**TO:** Casey Adragna, Adragna Architecture  
**FROM:** Elizabeth Steward, Associate Planner- Development Review  
**DATE:** 10/27/25  
**SUBJECT:** Douglas 234 Multitenant, Site Plan  
Review Comments 02

SITE PLAN  
**HORSE CREEK COMMERCIAL**  
 LOT 10B, DOUGLAS 234 FILING NO. 6, AMENDMENT 2  
 A PORTION OF THE SW 1/4, SE 1/4, SECTION 29, T6S, R66W, 6TH P.M.  
 TOWN OF PARKER, COUNTY OF DOUGLAS, STATE OF COLORADO

COVER SHEET  
 DOUGLAS 234 FILING NO. 6, AMD. 2  
 JOB NO. 24020  
 DATE: OCTOBER 3, 2025  
 SHEET C1

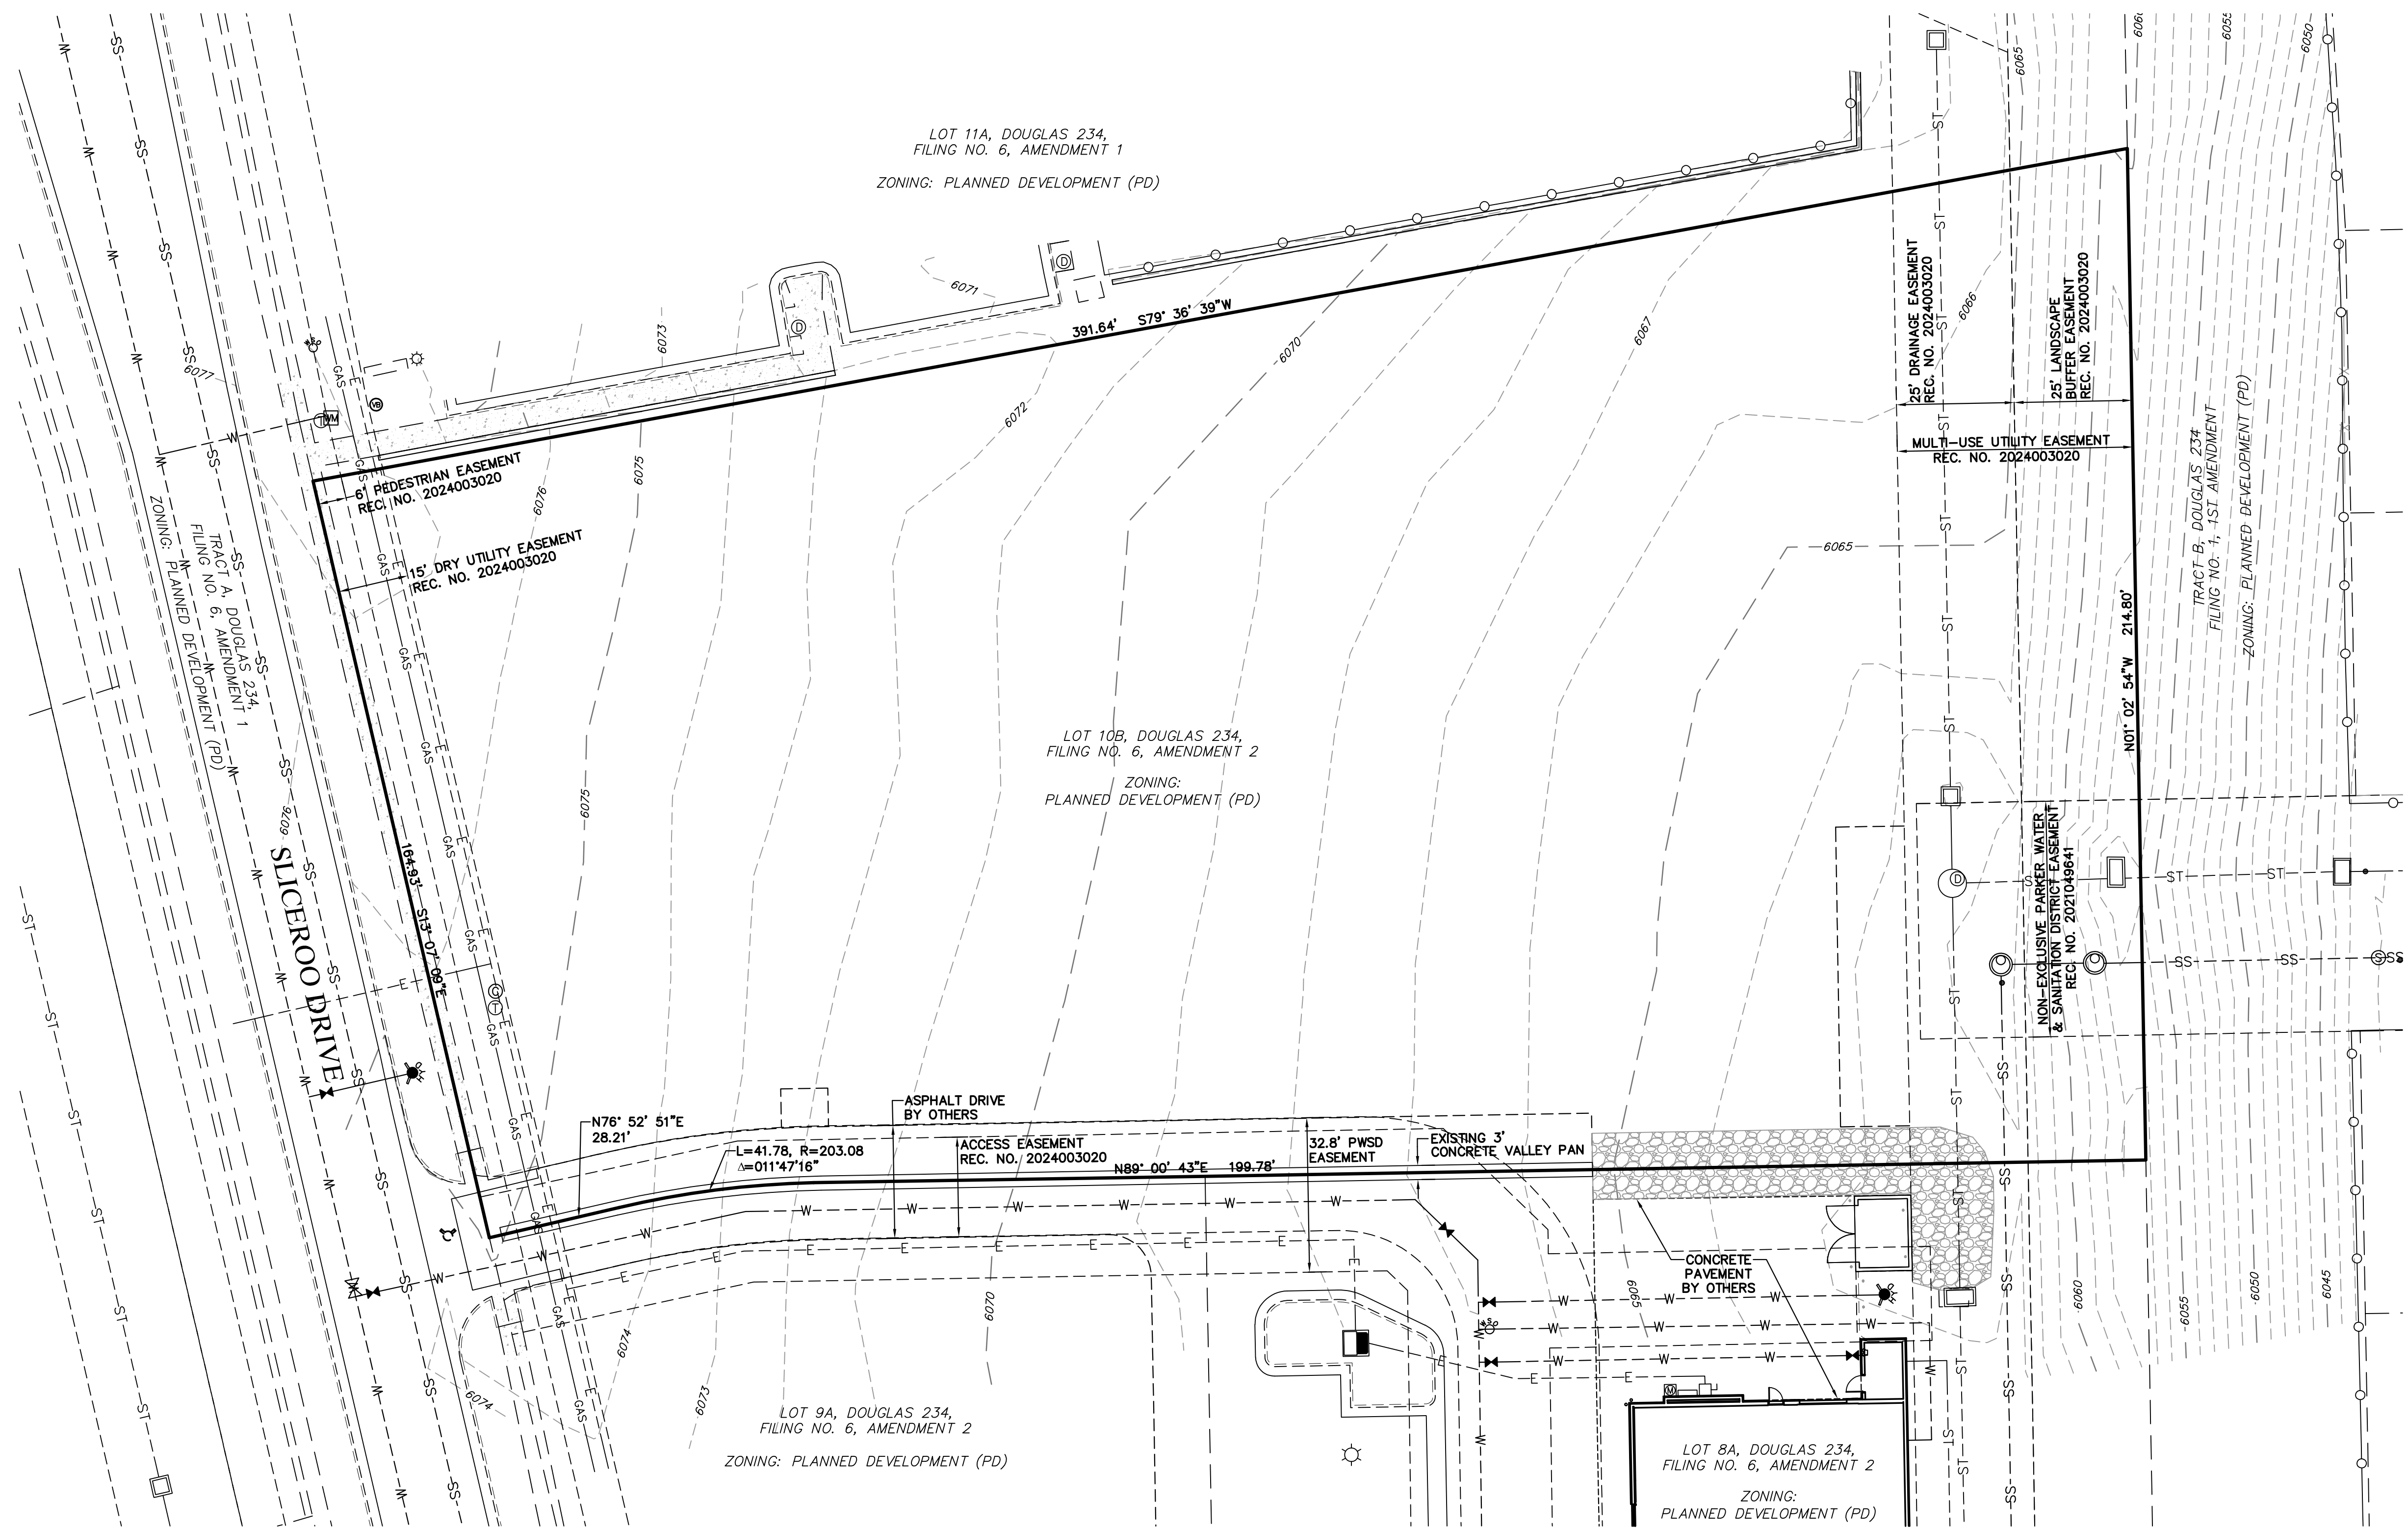
specify that this is the Max Height of structures allowed. This reads that the buildings are required to be 60ft.

revised

SITE PLAN  
 DOUGAS 234 FILING NO. 6, AMD. 2  
 JOB NO. 24020  
 DATE: OCTOBER 3, 2025  
 SHEET C3

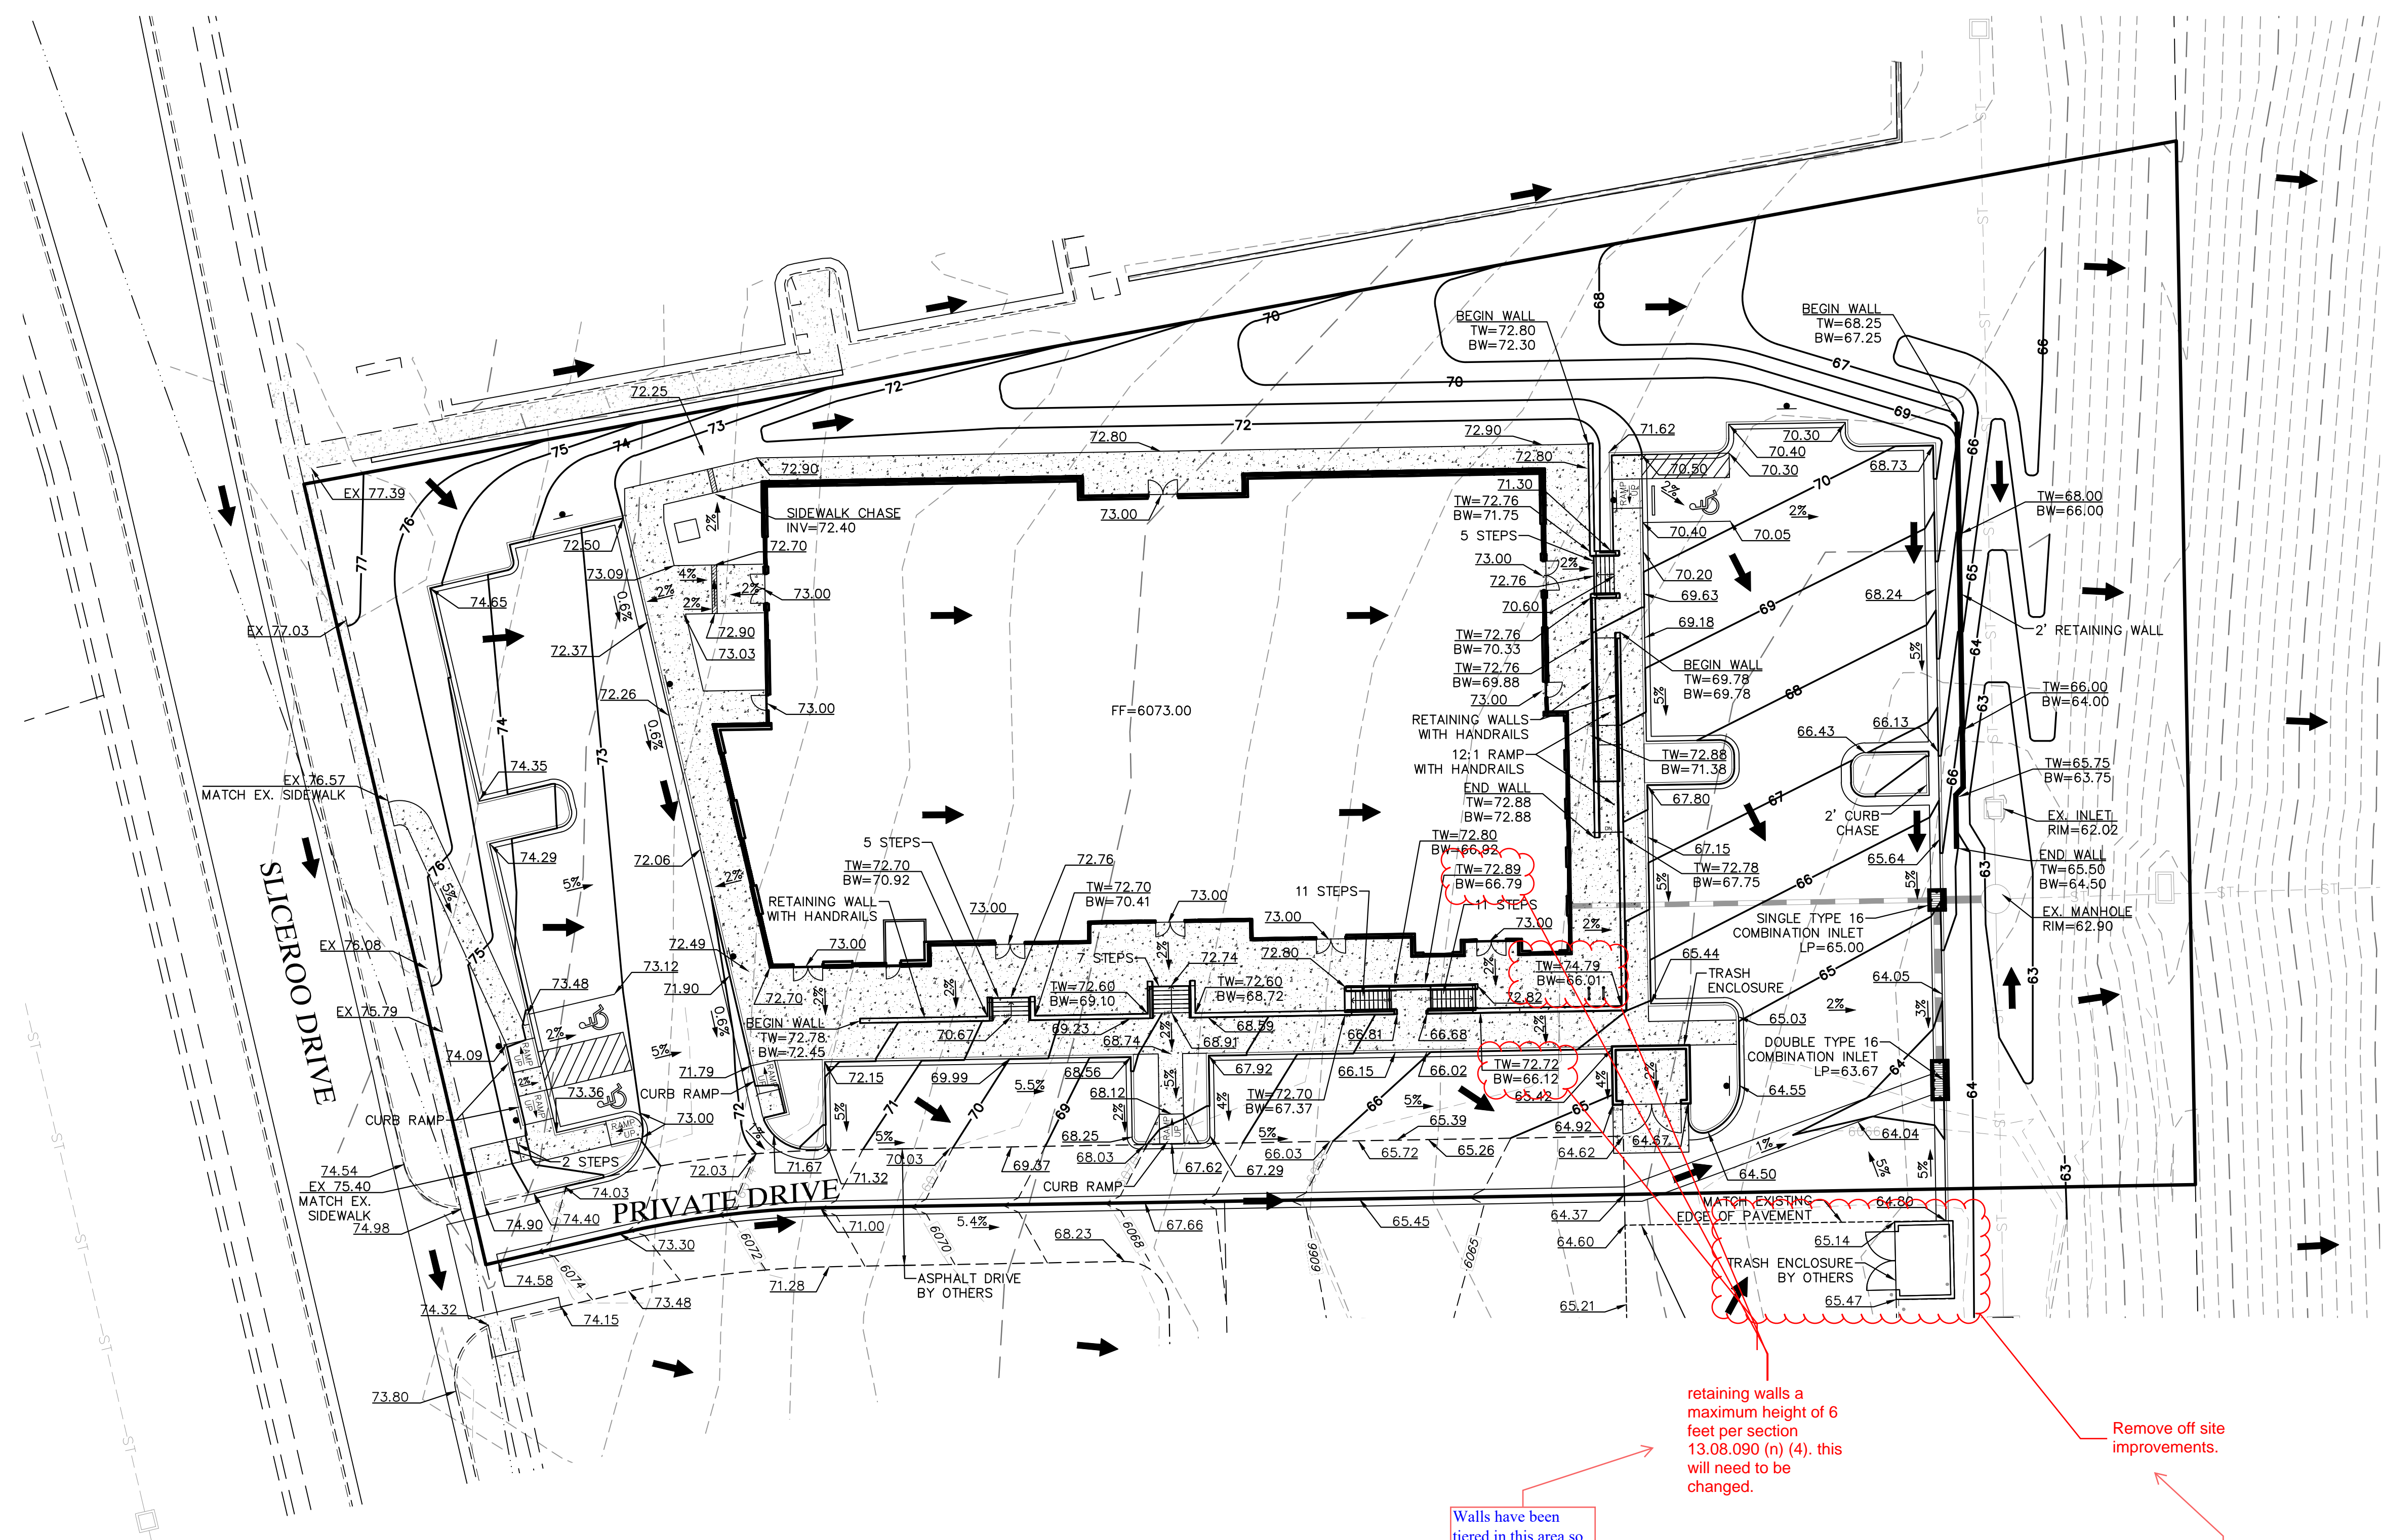
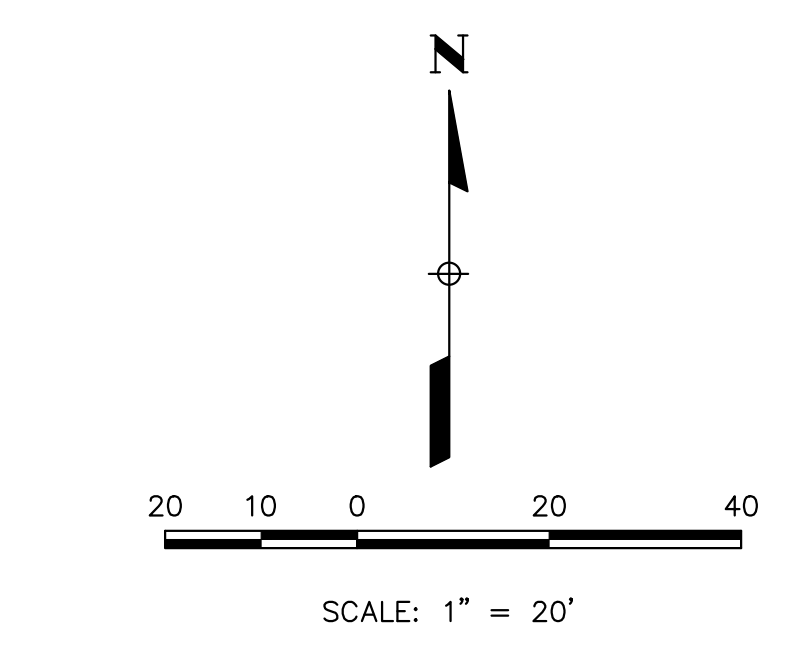
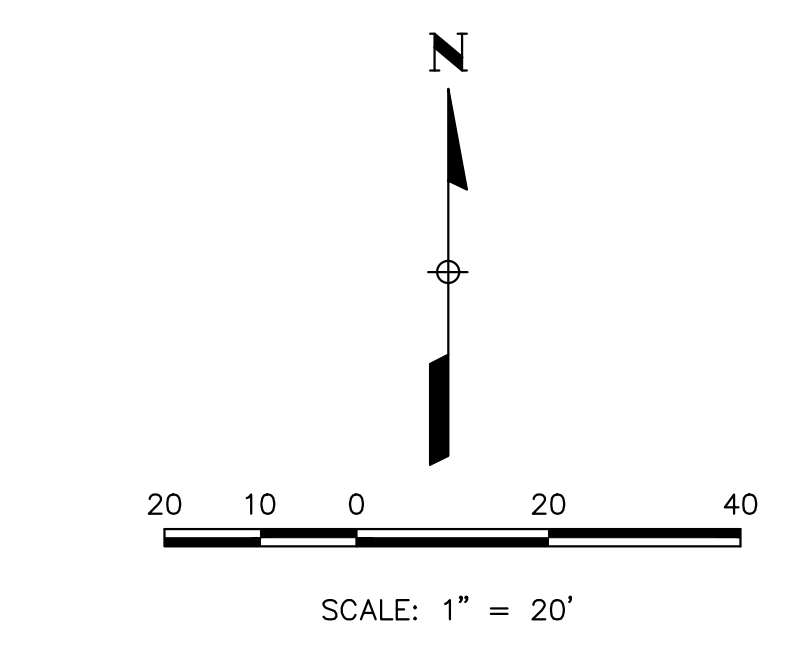
CORE will not allow screening at the front. This side needs to be open to the parking lot.

Can the transformer be moved back within this island? Room for screening at the front will be needed.

Bicycle parking is on raised level, this will make it hard to use. Can it be moved to the parking level more towards the frontage of the building? Section 13.08.080 (4) requires Bicycle parking facilities shall be located near building entrances, shall be visible from the primary entrance of the land use they serve

Retaining Walls Cannot exceed 6 feet in height. Correct.

Due to the drainage swale between the sidewalk chases the transformer could not be moved much closer to the building anyway.

The bike parking has been moved close to the center of the building.

revised
